Proposed Turkey Point Units 6 and 7  
Docket Nos. 52-040 and 52-041  
FPL Revised Response to NRC RAI No. 02.05.02-3 (eRAI 5896)  
L-2014-282 Attachment 2 Enclosure A Page 1 of 3

**NRC RAI Letter No. PTN-RAI-LTR-037**

**SRP Section: 02.05.02 - Vibratory Ground Motion**

**NRC RAI Number: 02.05.02-4 (eRAI 5896)**

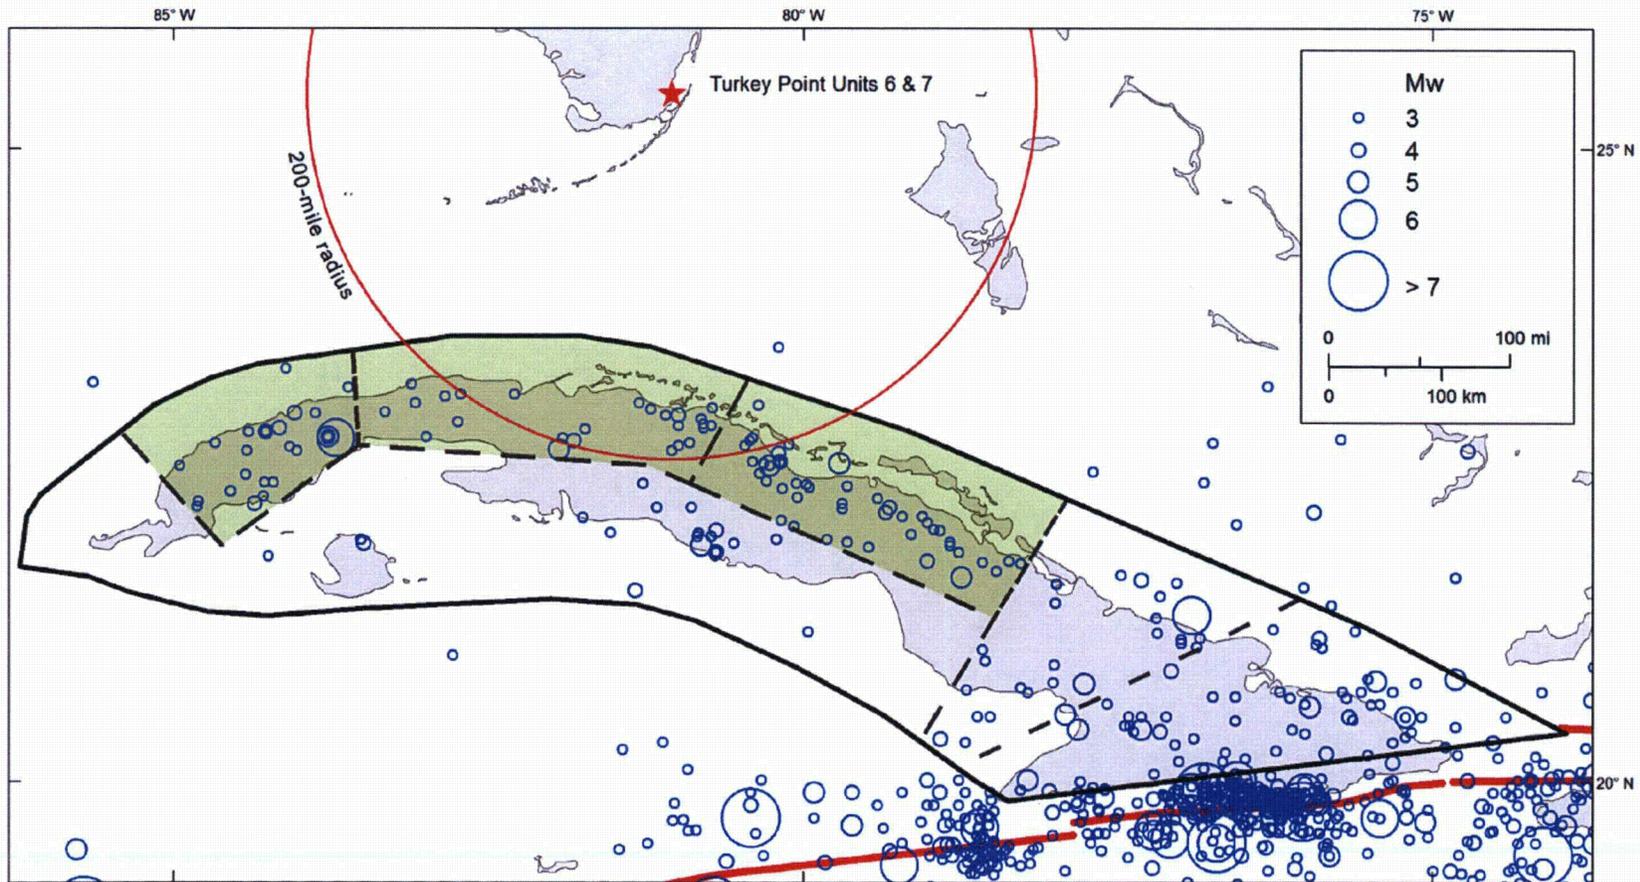
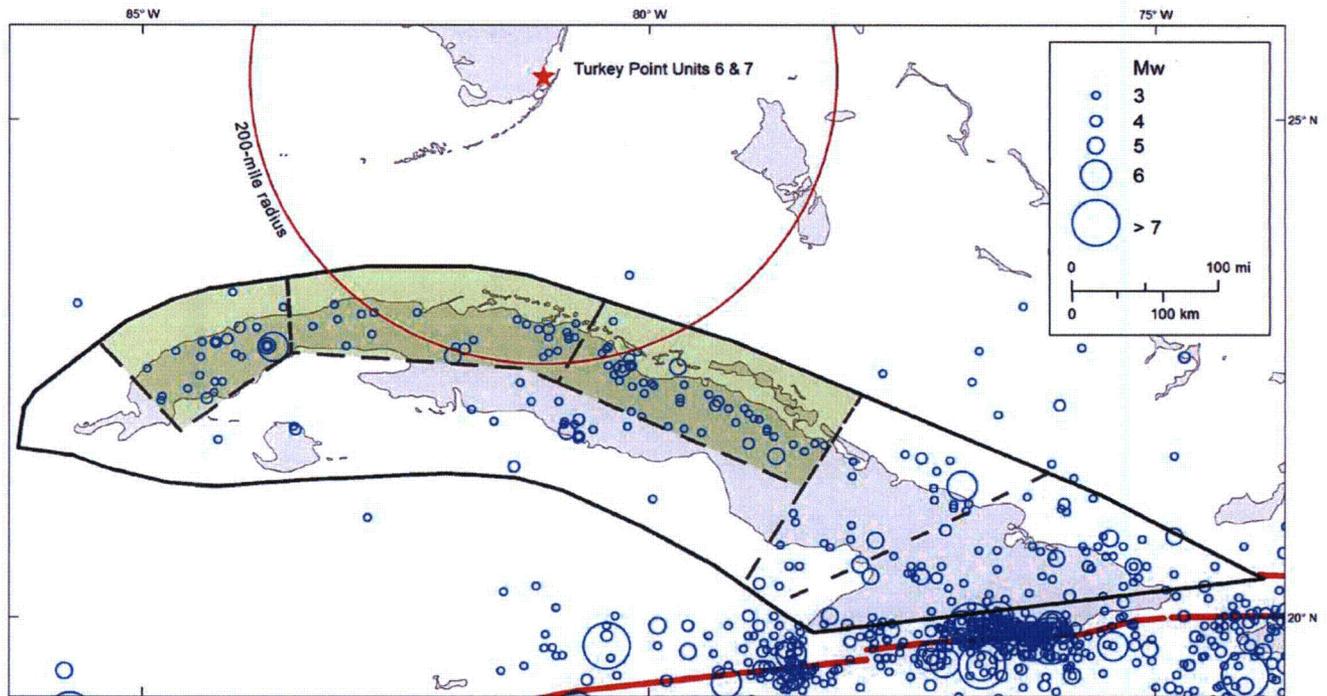
- c. A description of how well the seismic source model parameters represent the observed spatial patterns and concentrations of seismicity. Is a uniform seismic source zone justified considering FSAR Figure 2.5.1-267, which shows prominent clusters of seismicity? Discuss evidence, if any, that frequency-magnitude behavior is different for the subset of earthquakes concentrated in western and northern Cuba than for the entire zone.

- Six areal source zones scenario (Z6): In the six areal source zones scenario, Cuba is divided into six zones largely on the basis of observed patterns in seismicity (Figure 1). The seismicity *b*-value is constant across all six zones and equivalent to that used in the Z1 scenario; the seismicity *a*-values vary from zone to zone, are uniform within each zone, and are based on the observed seismicity within each zone. The Z6 scenario results in the lowest contribution to hazard from the three zone scenarios (Table 1).

If the Cuba areal source zone were to be subdivided in an attempt to model areas with higher rates of earthquake occurrence (Z6), this would result in areas of lower rates than the average uniform rate applied to the Cuba areal source zone. In particular, the offshore region of the Cuba areal source nearest the Turkey Point Units 6 & 7, which is nearly devoid of seismicity (Figure 1), likely would generate little or no hazard. Therefore, this modification may result in a less conservative characterization if the reduction in hazard from the nearest portion of the zone is greater than any increases in hazard from more distant areas of higher seismicity in Cuba. This point is illustrated by inspection of FSAR Figure 2.5.2-227, which shows the  $M$  and  $R$  deaggregation for 5 and 10 Hz for the  $10^{-4}$  uniform hazard response spectrum (UHRS). The Cuba areal source contribution to the site hazard appears in the  $M_w$  6.5 to 7.5 range and abruptly begins appearing in the 210 to 240 kilometer (130 to 150 mile) distance bin and beyond. The closest distance from the site to the Cuba areal source is approximately 220 kilometers (140 miles).

Seismicity in Cuba is not perfectly uniform, in that the density appears to be greatest in the southeast, west, and north-central portions of the island. In recognition of this, a “northern Cuba subzone” was defined that encompasses apparently higher than average seismicity in the north of Cuba (Figure 1). The northern Cuba subzone rate is found to be approximately 11% higher than the single-zone (Z1) rate, on a per-area basis. This 11% increase is then conservatively applied to the entire single areal zone rate to develop the Z11% scenario. The only difference between the Z1 and Z11% model is a +11% difference in rate in the latter. The effect of this rate increase on the PSHA results is discussed in part (a) of the current response. The following discussion provides details on the development of the Z11% model.

- **Six areal source zones scenario (Z6):** In the six areal source zones scenario, Cuba is divided into six zones largely on the basis of observed patterns in seismicity (Figure 2.5.2-271). The seismicity *b*-value is constant across all six zones and equivalent to that used in the Z1 scenario; the seismicity *a*-values vary from zone to zone, are uniform within each zone, and are based on the observed seismicity within each zone. For the six-zone scenario (Z6), the *a*-values were determined by counting the number of events in each subzone greater than or equal to  $M_w$  3.0. The *b*-value in base case Z1 is used for all six subzones. The Z6 scenario results in the lowest contribution to hazard from the three zone scenarios (Table 2.5.2-233).

Figure 2. Map of intraplate Cuba fault sources as modeled for hazard sensitivity calculations.

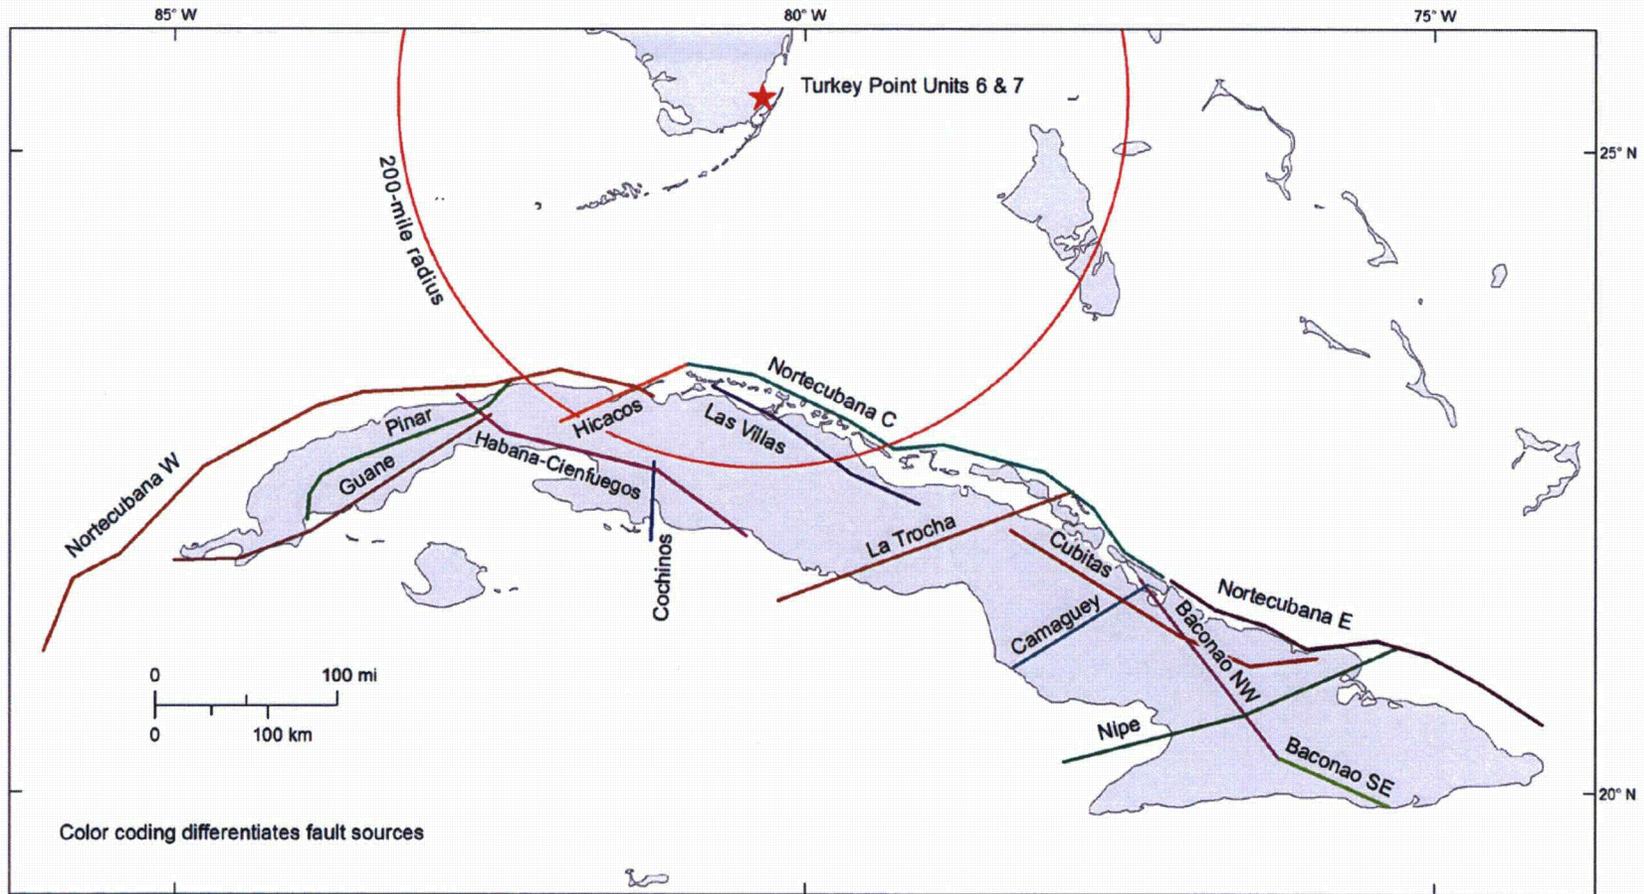
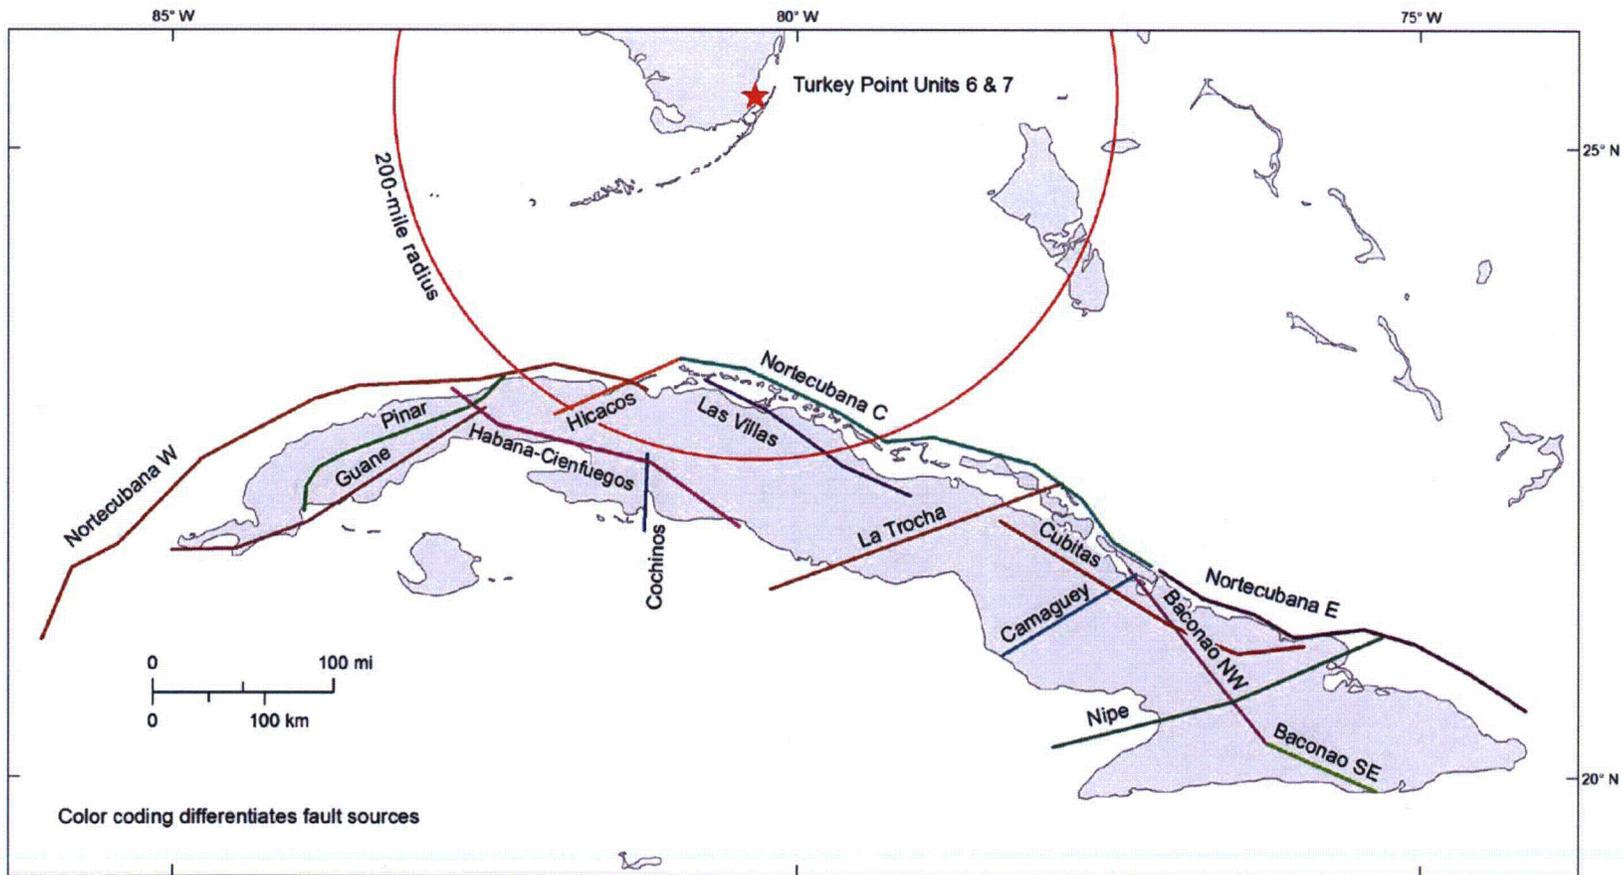
FSAR Subsection 2.5.1.1.1.3.2.4 describes that due to lack of knowledge about individual faults' characteristics, the applicant used an areal source zone to model the seismic hazard from the Cuban seismic sources. In accordance with NUREG-0800, Standard Review Plan, Chapter 2.5.2, "Vibratory Ground Motion," and Regulatory Guide (RG) 1.208, "A Performance-Based Approach to Define the Site-Specific Earthquake Ground Motion," please provide the following:

The detailed characterization of sensitivity fault sources in Cuba is described in the response to RAI 02.05.01-21 and the sensitivity of hazard results is provided in part (a) of this (current) response. For the hazard sensitivity calculations, there are three scenarios for fault sources, as shown in Table 1 and summarized below.

Rodriguez et al.'s (Reference 321) seismoactive faults in Cuba plus the Pinar fault (Figure 2.5.2-272). For the purpose of the hazard sensitivity calculation, it is assumed that all of these faults are capable tectonic sources. The Nortecubana fault is divided into three sensitivity fault sources, the Nortecubana West, Nortecubana Central, and Nortecubana East fault sources. The Baconao fault is divided into two sensitivity fault sources, the Baconao Northwest and the Baconao Southeast fault sources. Seismogenic depth for all fault sources in the hazard sensitivity calculation extends from 0-15 kilometers (0-9 miles). All fault sources are modeled with vertical dip angle, except the three Nortecubana fault sources, all of which are modeled as dipping 30 degrees to the south.

**Figure 3.** 1 Hz mean hazard curves showing sensitivity to Cuba source scenarios. Lower panel is expanded view of yellow box in upper panel.

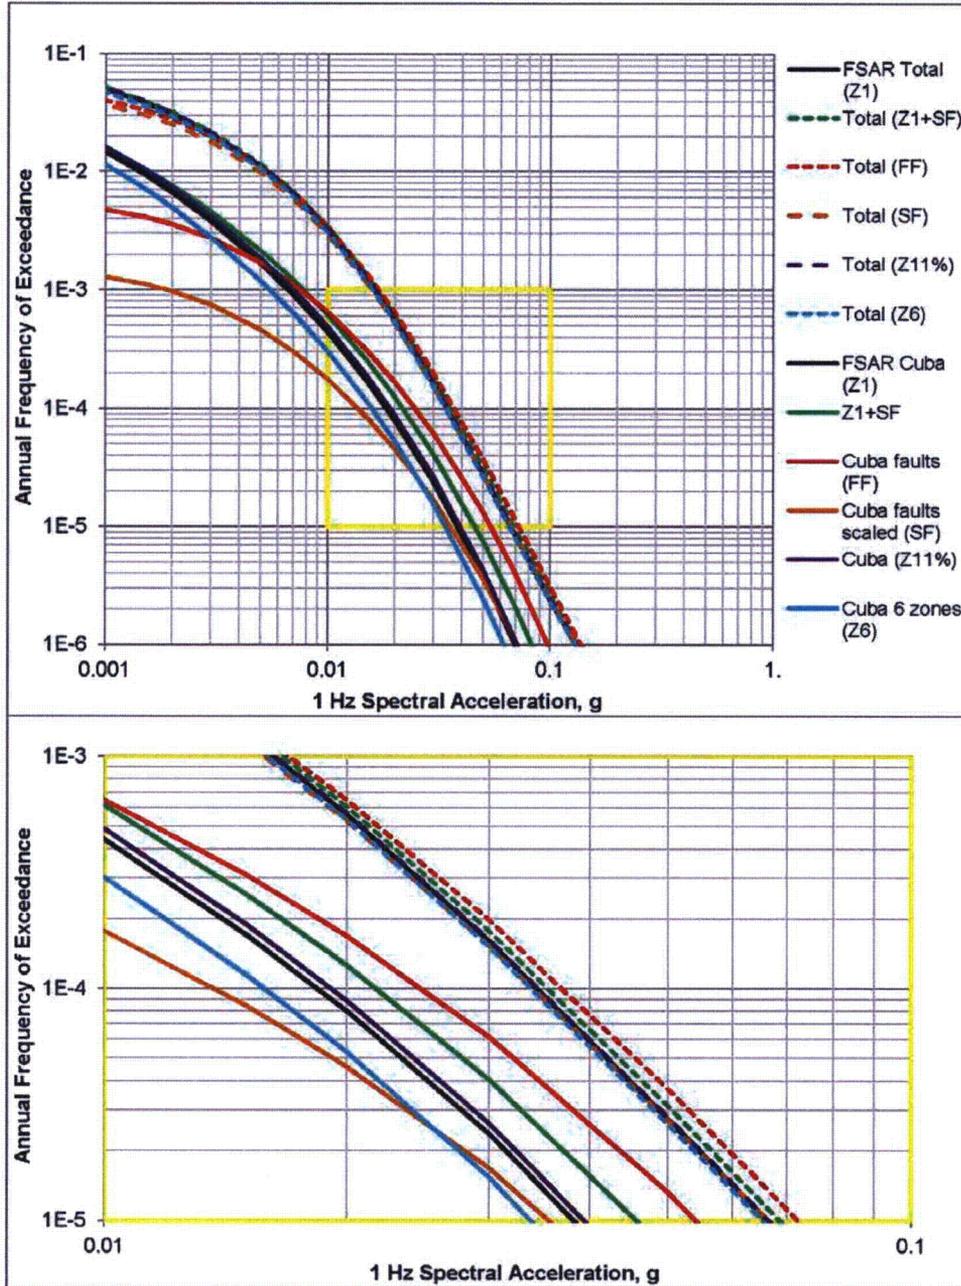
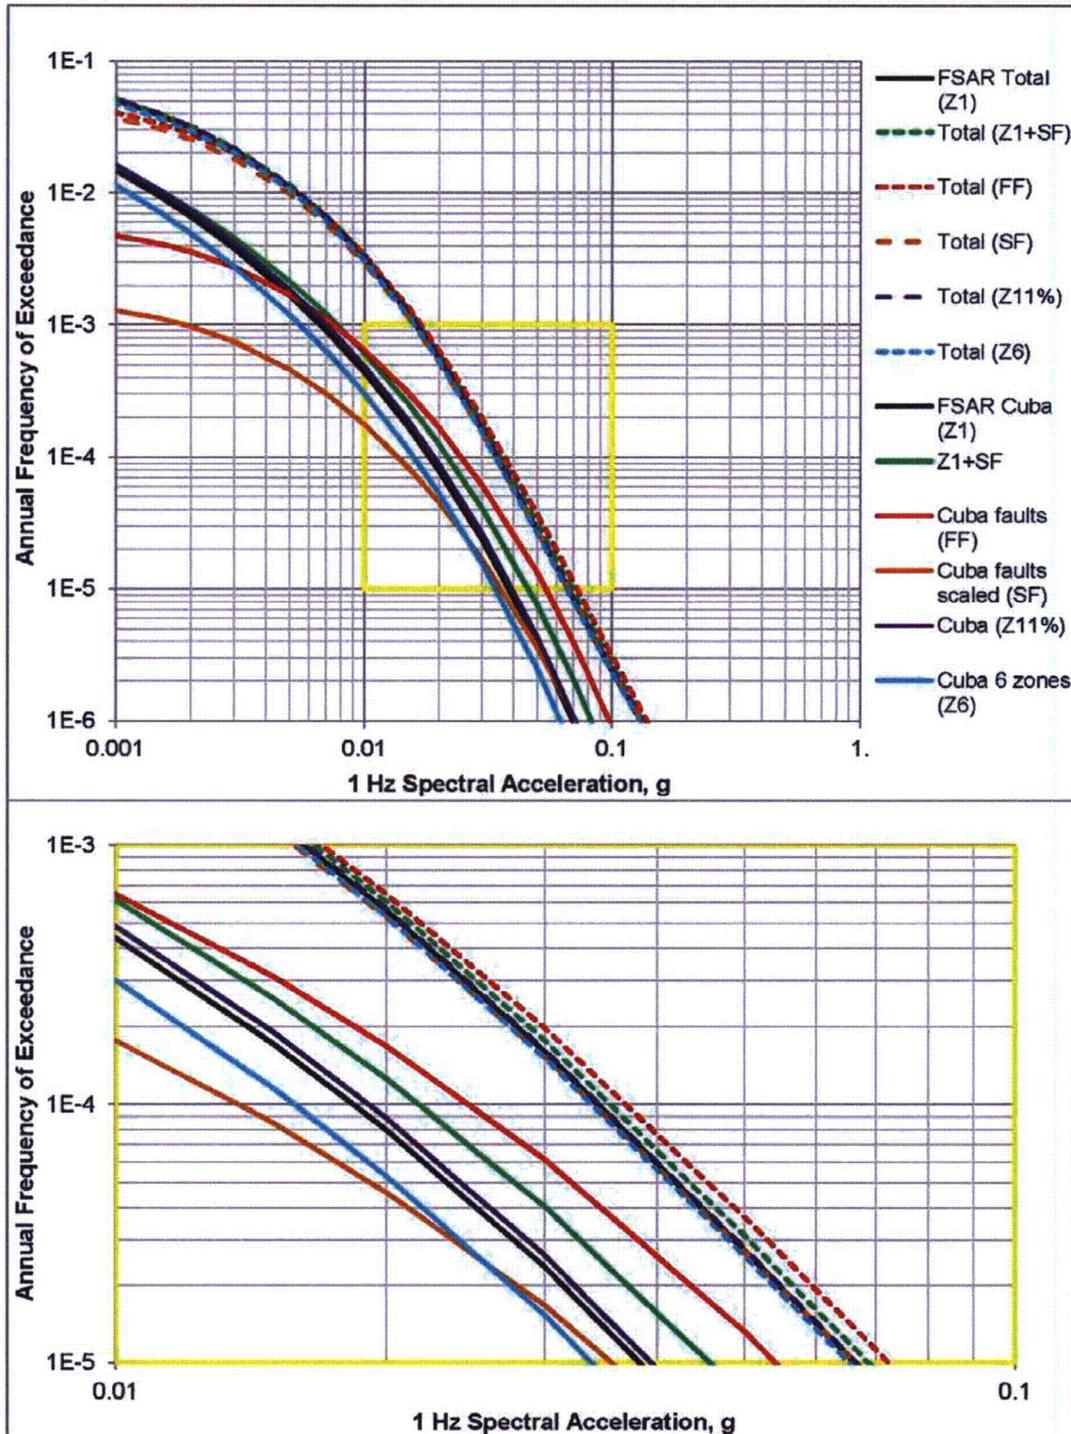
- a. Rationale for the exclusive use of an areal source rather than multiple areal sources or a combination of fault sources and areal sources. Given the uncertainties, does the use of a single areal source result in a more conservative representation of the hazard from the Cuba seismic sources?

In order to assess the impact of various Cuba sensitivity scenarios on the Turkey Point Units 6 & 7 site hazard, based on the evaluation of the hazard results presented in Figures 3 and 4, four sensitivity scenarios (Z6, Z11%, SF, and Z1+SF) were selected to represent the Cuba hazard in lieu of the Z1 base case scenario used for the original FSAR hazard total. Total hazard curves that include these four scenarios are presented in Figure 5, along with the original FSAR total hazard.

To assess the impact of various Cuba sensitivity scenarios on the Turkey Point Units 6 & 7 site hazard, based on the evaluation of the hazard results presented in Figures 2.5.2-273 and 2.5.2-274, four sensitivity scenarios (Z6, Z11%, SF, and Z1+SF) were selected to represent the Cuba hazard in lieu of the Z1 base case scenario used for the original base case hazard total. Total hazard curves that include these four scenarios are presented in Figure 2.5.2-275, along with the original total hazard.
